Polaris RZR XP1000 Safety Recall Z-16-01 Identification

Z-16-01-D. *Heat shield replacement.* Heat indicated by the

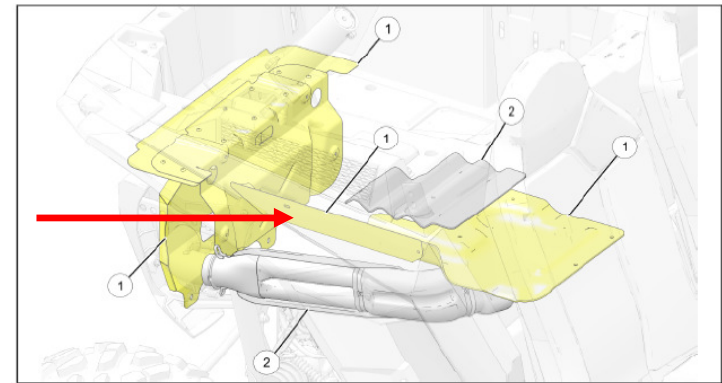
red arrow is not present with the original shielding.

The other 3 shields in yellow have been upgraded

Z-16-01-E. *Fuse Box Seal Replacement.*

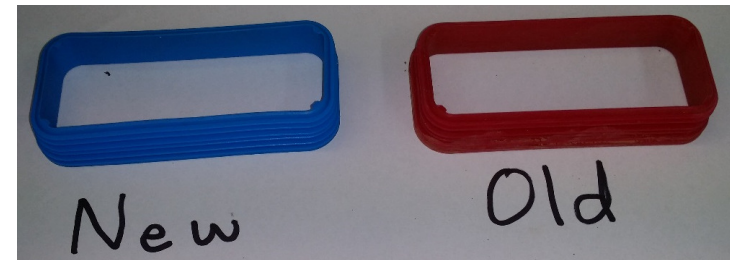
Old seal is red, replacement new seal is blue
